Attorney Docket No.: 106E-0023CIP
Serial No.: 09/907,260

Appl. No. 09/907,260
RCE Dated October 14, 2003
Reply to Advisory Action Dated September 4, 2003
Annotated Sheet Showing Changes

Fig.2

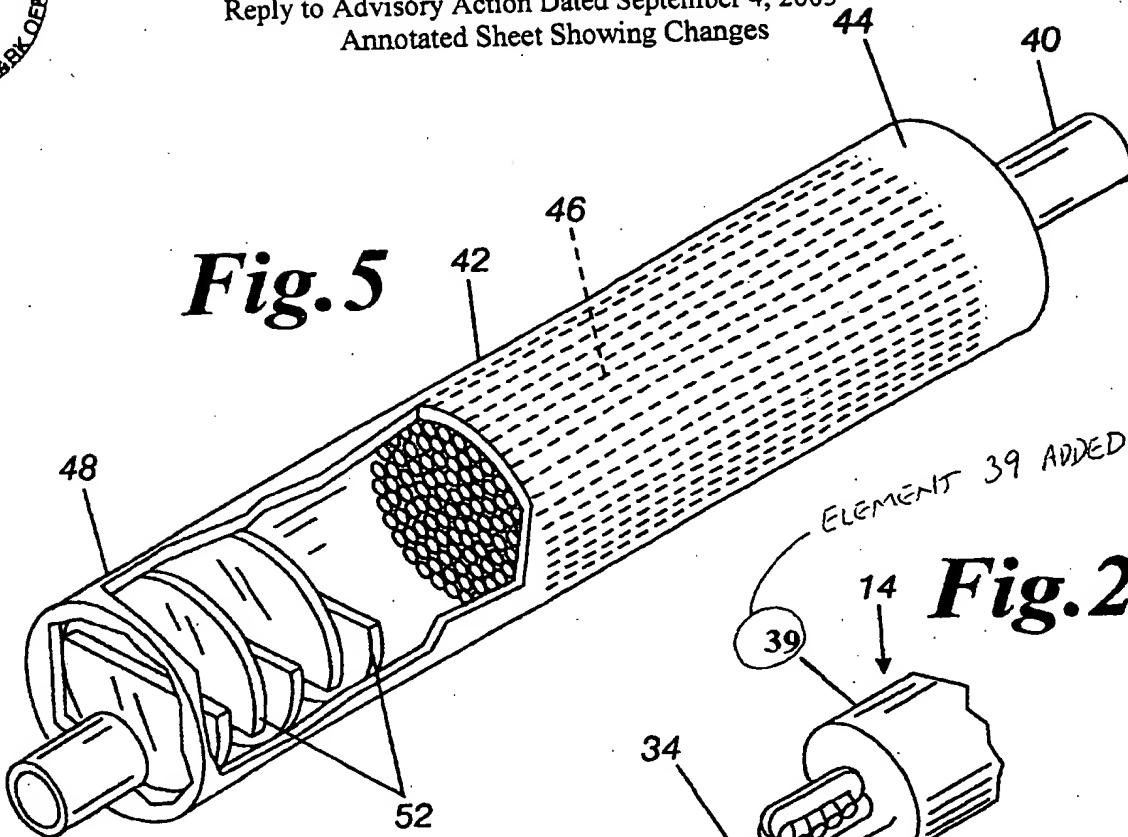
In amended Figure 2, the previously omitted element numeral 39 has been added.

ELEMENT 39 ADDED
